The **TRIUMPH** Service Sheets and other Technical Data Collection

Service 1 Contents List

FIG.4.

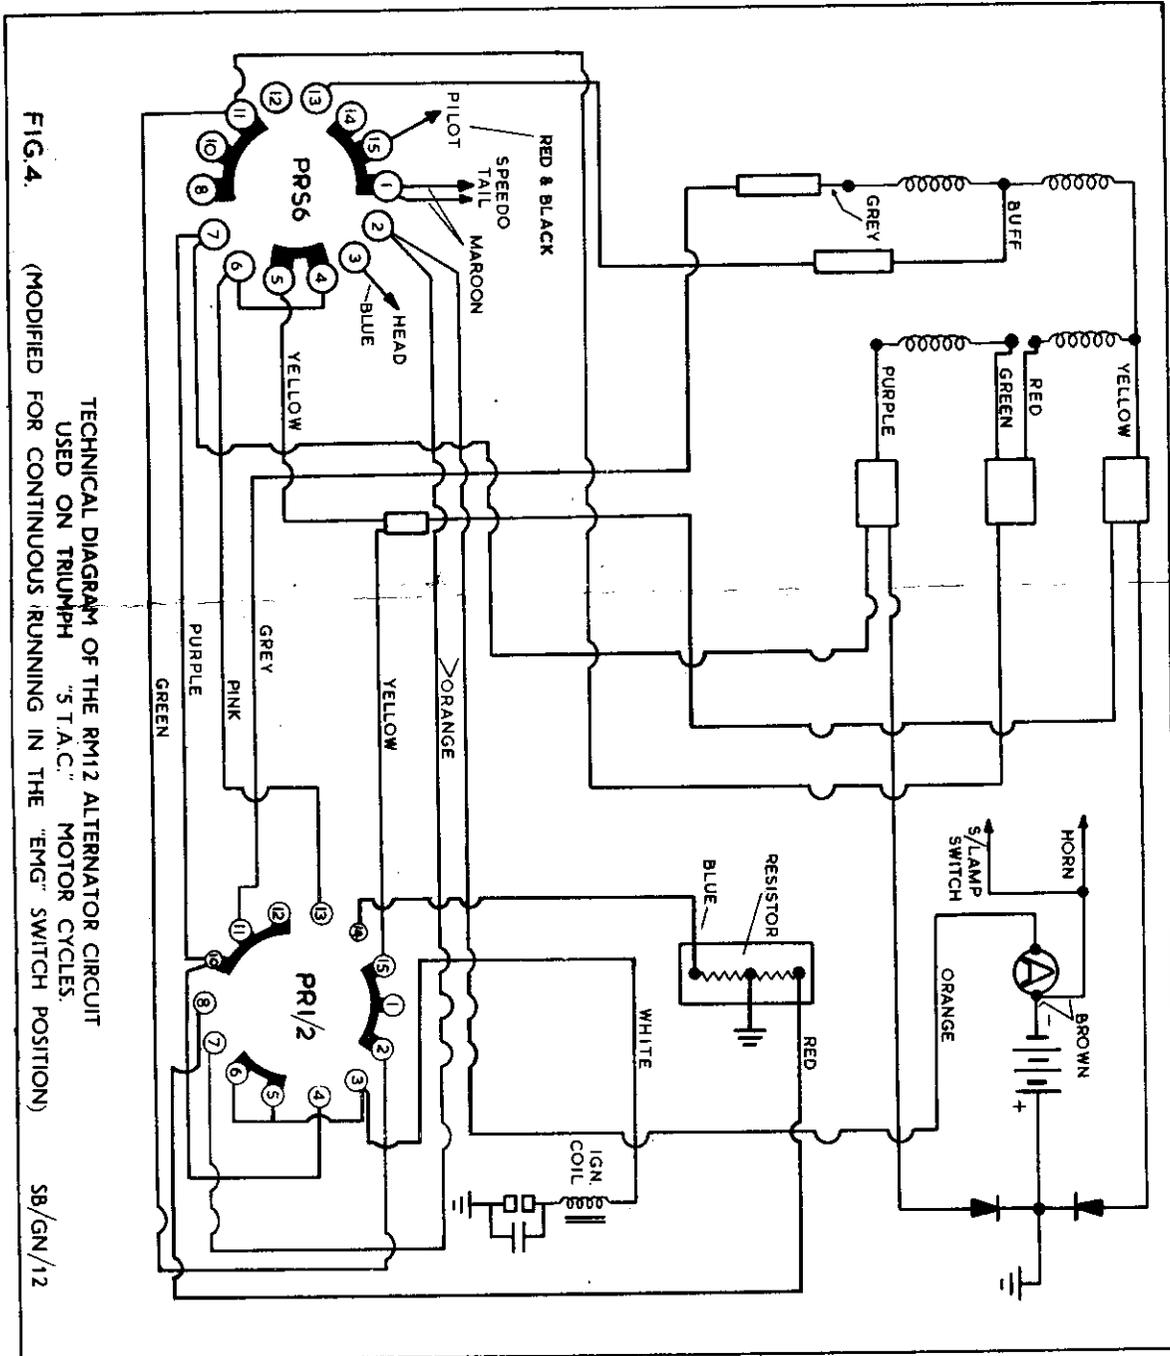
(MODIFIED FOR CONTINUOUS RUNNING IN THE "EMG" SWITCH POSITION)

DIAGRAM OF THE RM12 ALTERNATOR CIRCUIT
 USED ON TRIUMPH 5T.A.C. MOTOR CYCLES.
 (MODIFIED FOR CONTINUOUS RUNNING IN THE EMG SW. POSITION)

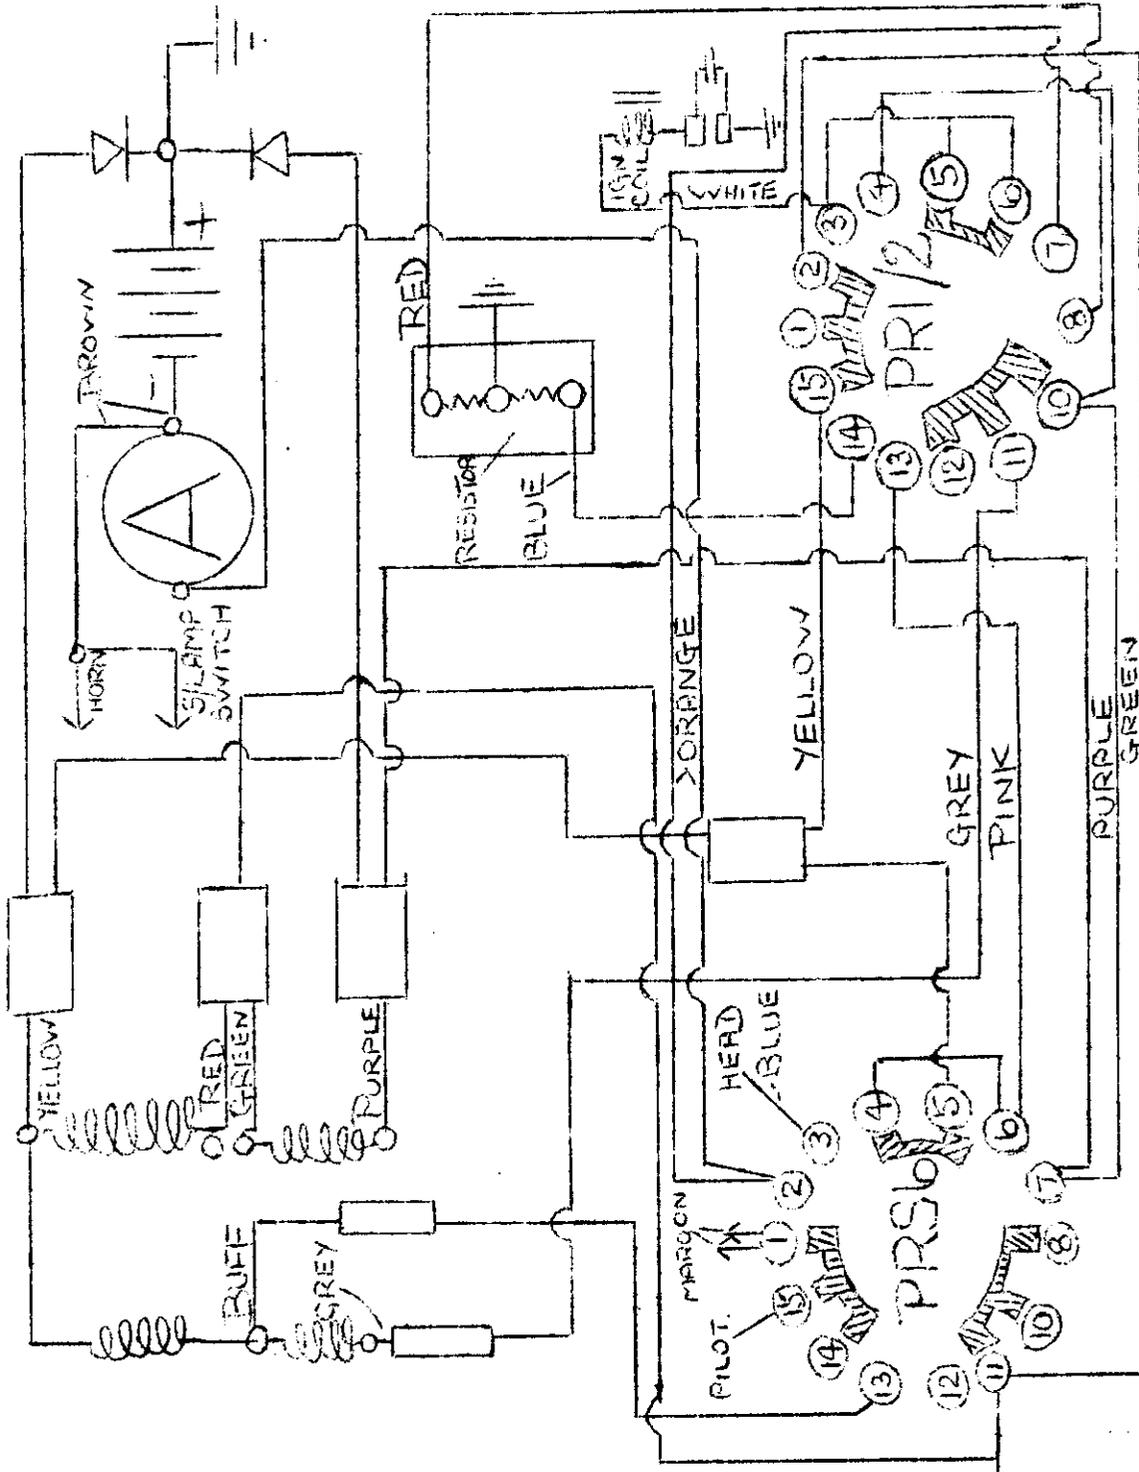
These are known as Series C. These have a Double Wound Alternator 47095 having six leads and a single bank rectifier 47097 and a resistance to provide for continuous running in the "EMG" position.

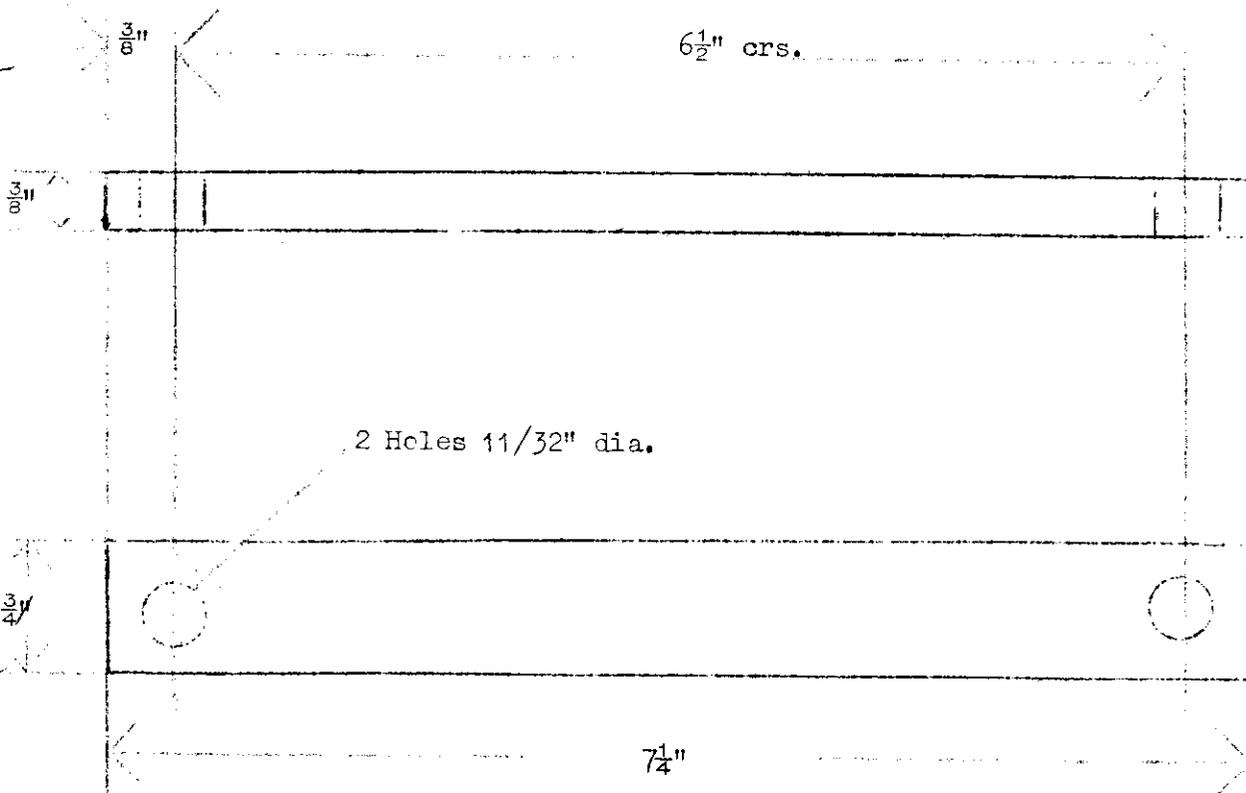
To assist in removing the Terrier and Cub drive side inner cover, two of the screw holes at 6 o'clock and 12 o'clock relative to the engine mainshaft have been drilled and tapped 5/16 ins. x 22 BSF. An extractor bar part number D342 is available from the Triumph Spare Parts Department or may be made locally from the drawing below. (NOT TO SCALE).

Remove sharp corners.

MODIFICATION TO TERRIER AND TIGER CUB OIL PUMP.

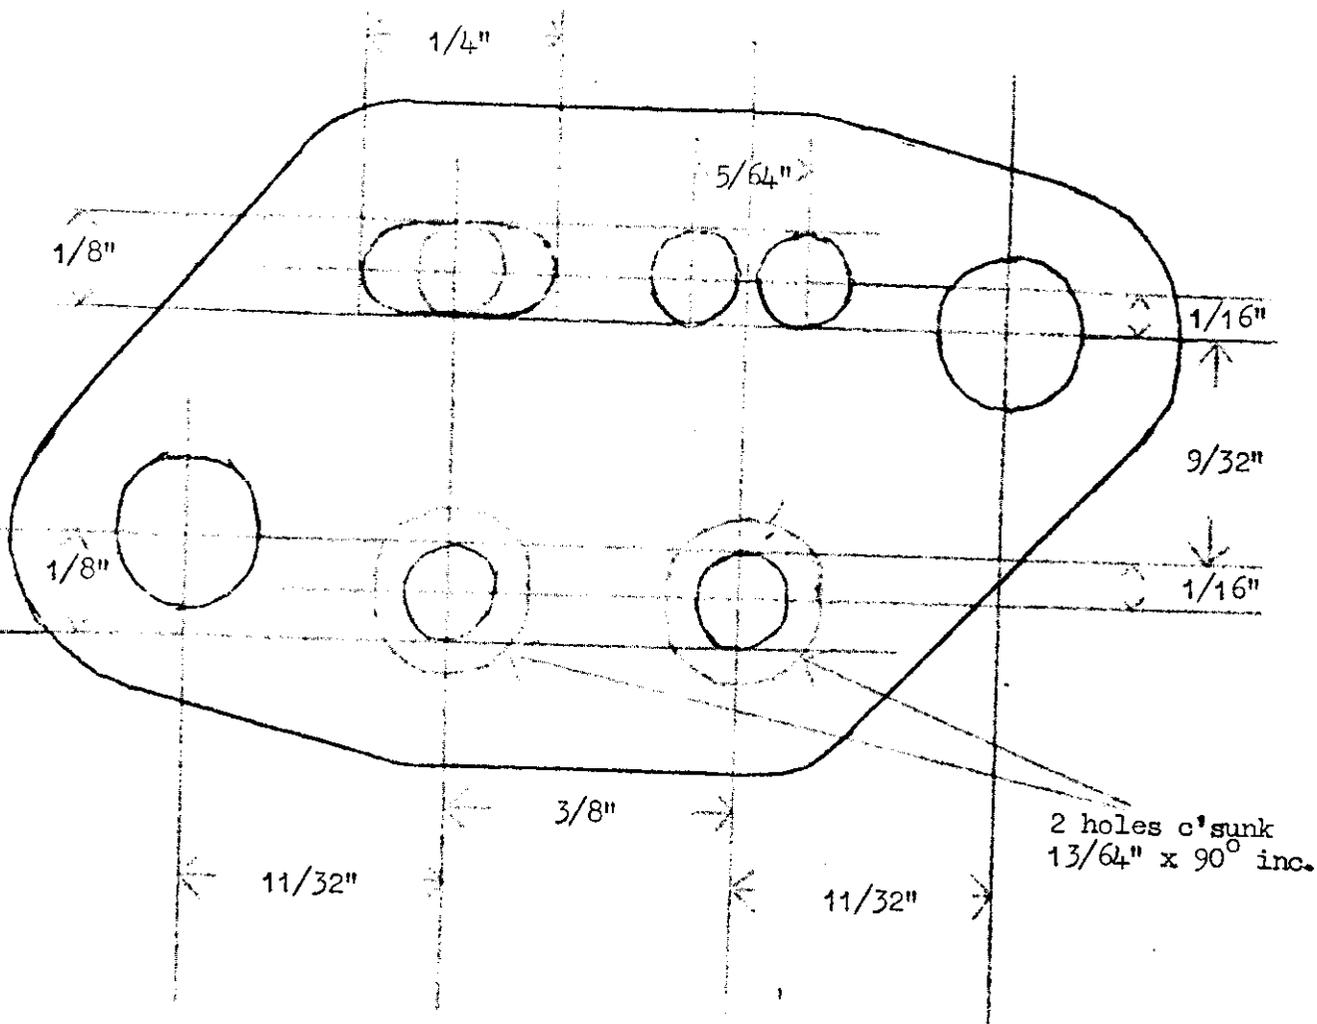
The 1/8 in. diameter inlet hole to the oil feed plunger, of the Terrier and Cub oil pump, has been enlarged to a slot 1/8 in. deep x 1/4 in. long.

It is very desirable that this modification is made, whenever an earlier machine is being overhauled, by drilling a 1/8 in. diameter hole on each side of the existing hole. A drawing of the oil pump face is shown below to assist the construction of a simple drill jig or guide plate. (The fixing holes are .1935 in. diameter No. 10 drill).

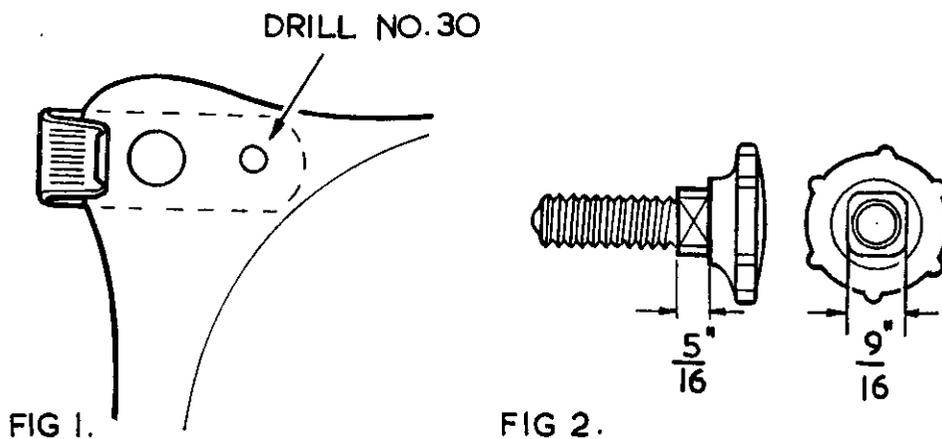
Remove the toolbox from the machine and position the spring clip as shown below in Figure 1. Using a No. 30 (.1285 in. dia.) drill, drill through the toolbox at the point shown. The clip should be fitted at the back of the toolbox and secured with the pop rivet which should also be fitted from behind.

The plastic screw must be modified by filing four flats to the dimensions shown in Figure 2. Alternatively, an already modified screw can be purchased under part number F11357.

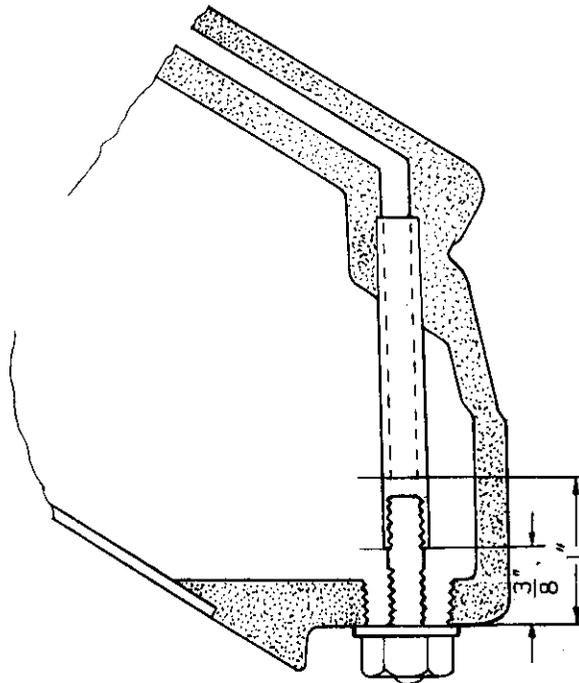
Commencing engine number DU88714, all 650 c.c. (40 cu.in.) engines have been fitted with a $\frac{5}{8}$ in. shorter crankcase oil scavenge tube. This has the effect of raising the crankcase oil level.

This modification enables the pistons, cylinder barrel and connecting rods to operate at a lower temperature, and the additional oil obviates excessive wear on the camshafts and cylinder bores.

FLEXIBLE HANDLEBAR MOUNTINGS ON 650 c.c.
HOME MARKET AND GENERAL EXPORT MACHINES

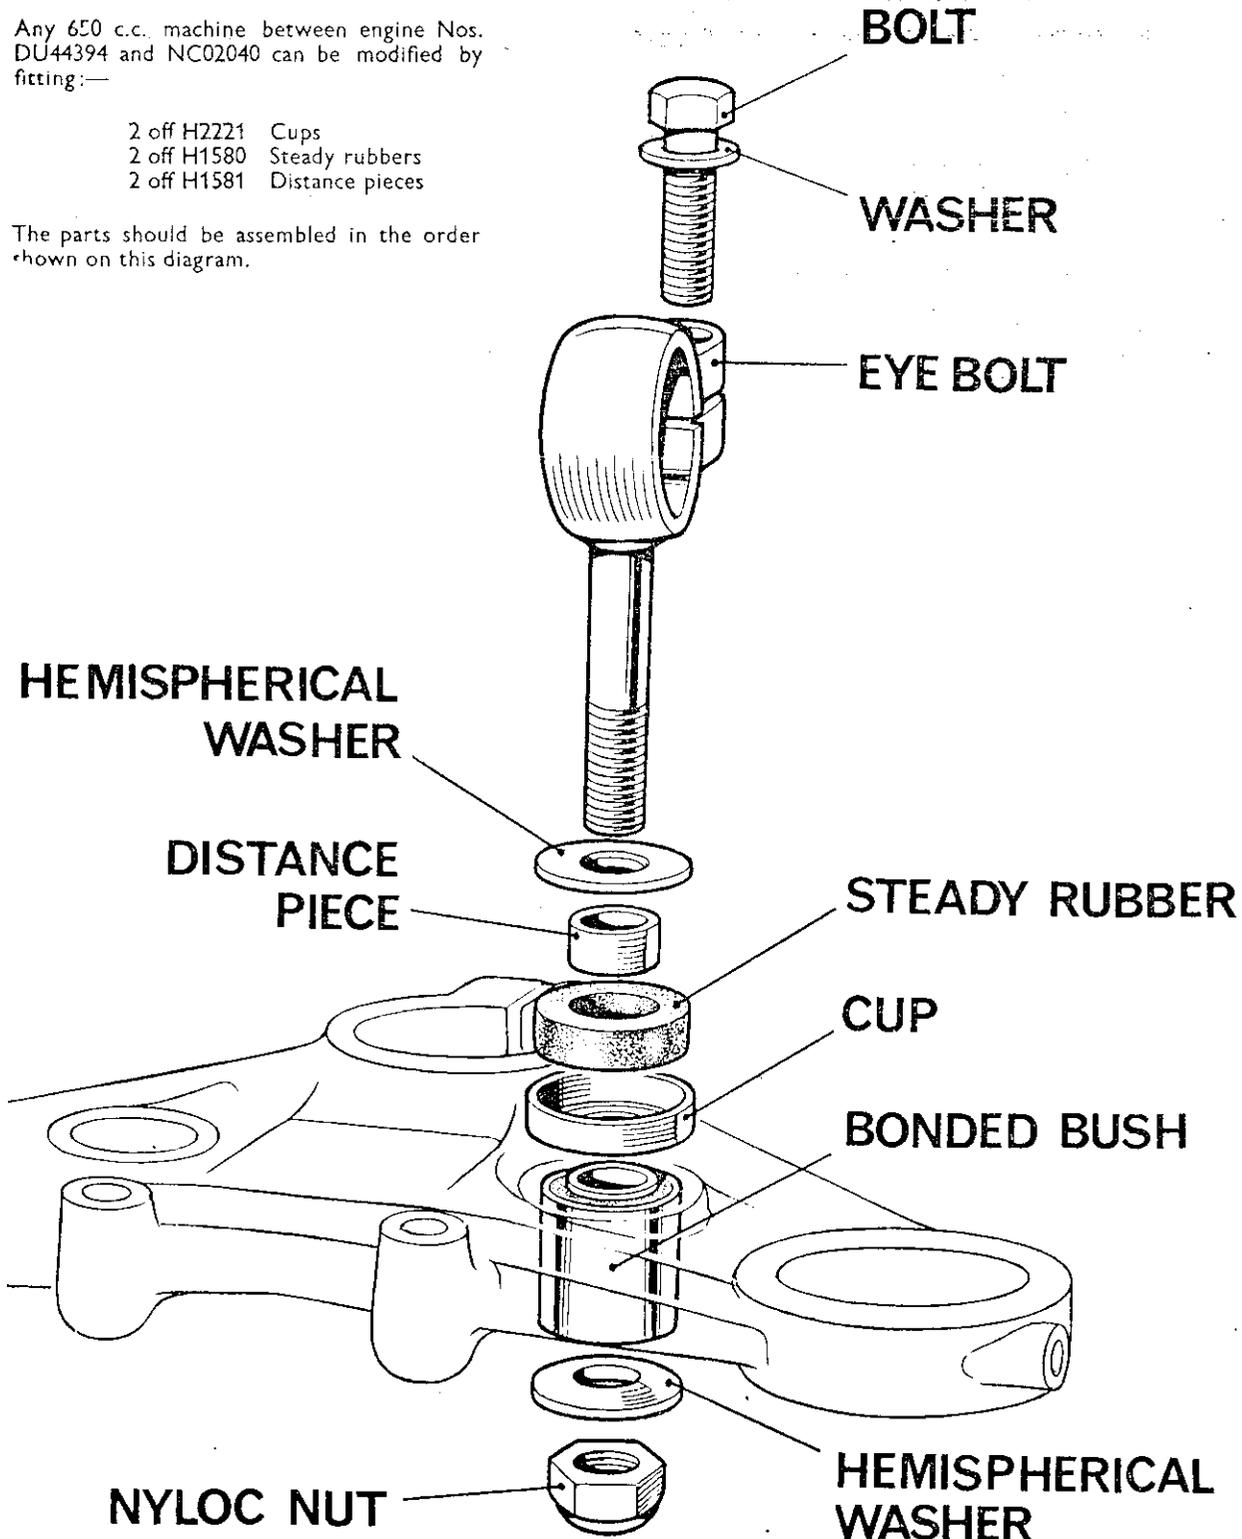
The introduction of a steering lock to the front fork top lug has created a condition whereby the handlebar can be moved sufficiently in the flexible mountings to cause contact between the eye bolt and frame head lug.

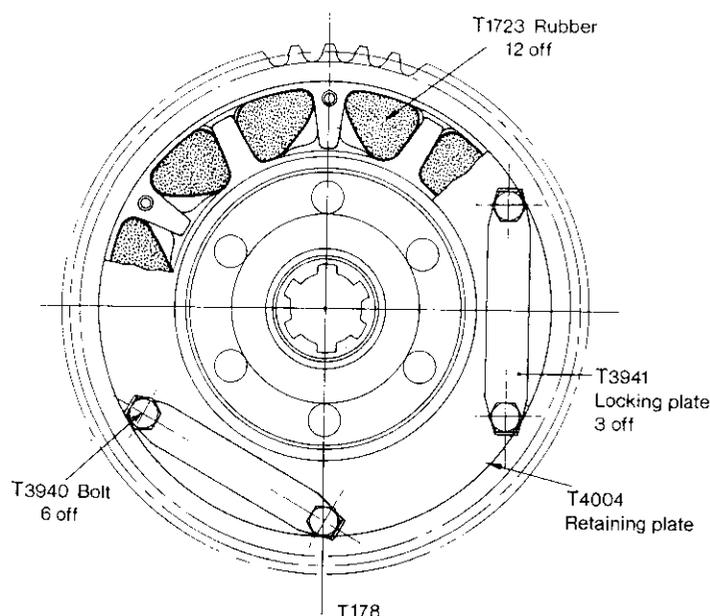
A production modification is being carried out whereby "B" Range cush drive rubbers replace those at present specified for the Trident.

It is suggested that when the transmission is dismantled in order to carry out the modification described in Section 1, or for any other reason, twelve T1723 rubbers are fitted in the positions shown.

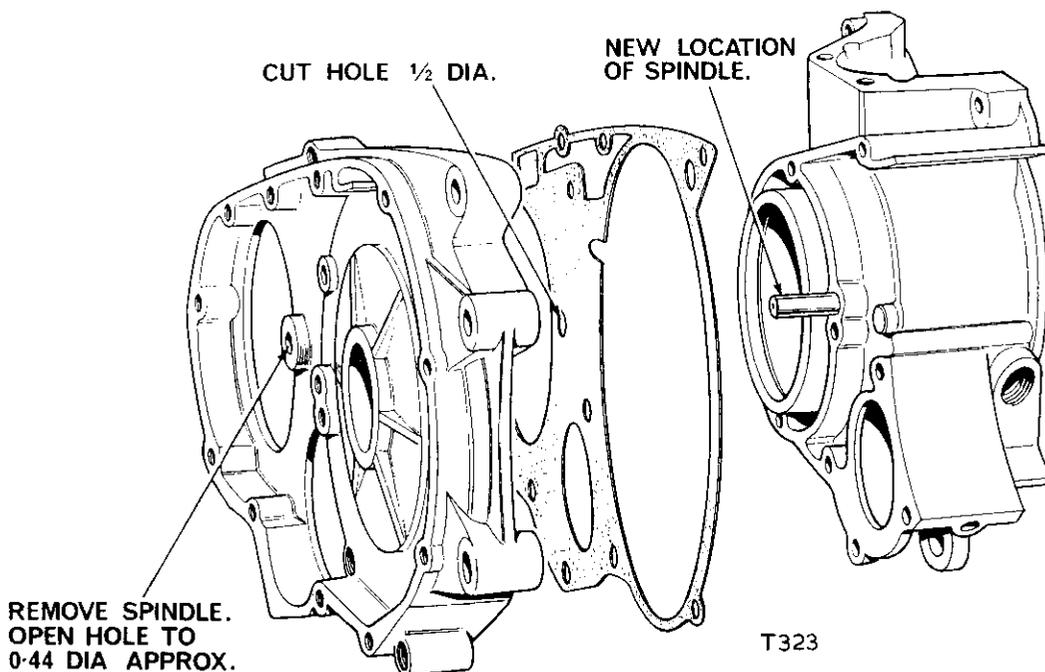
Prior to this modification the spindle (E6881) was pressed into an interference fit counterbored hole in the inner chaincase. On modified machines, the new spindle is located in the left side crankcase, and the hole in the inner chaincase is opened to allow the spindle to pass through freely. Because of this, no positive location is required for the inner chaincase, therefore one crankcase to chaincase dowel is omitted from the front of the chaincase. The dowel between the inner and outer chaincase must be retained.

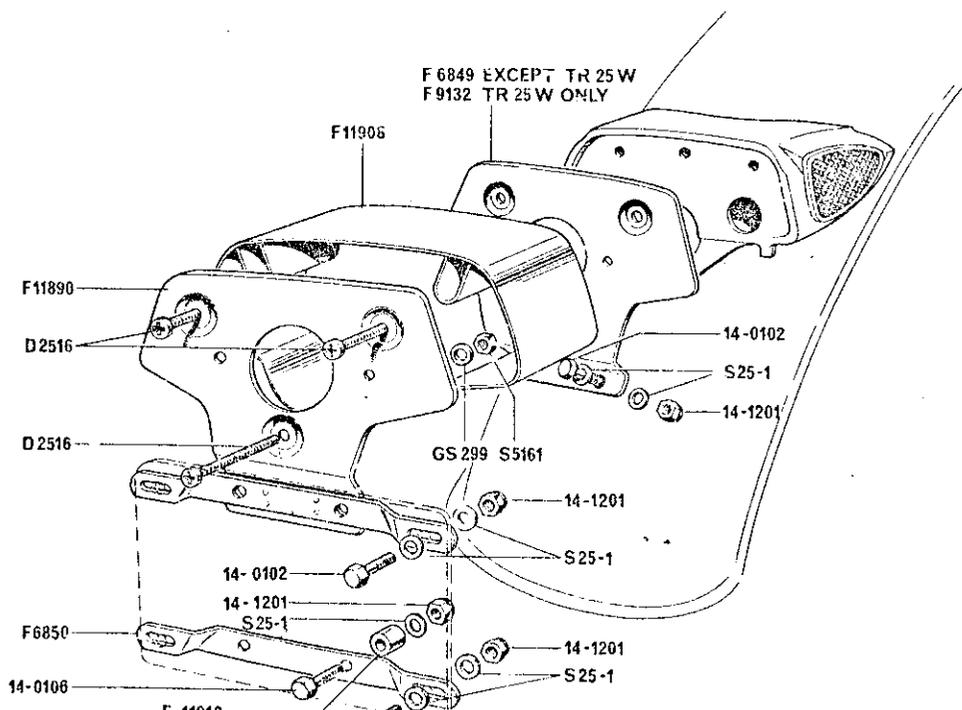
The tail lamp support should be reassembled with the new parts as shown on the accompanying diagram.
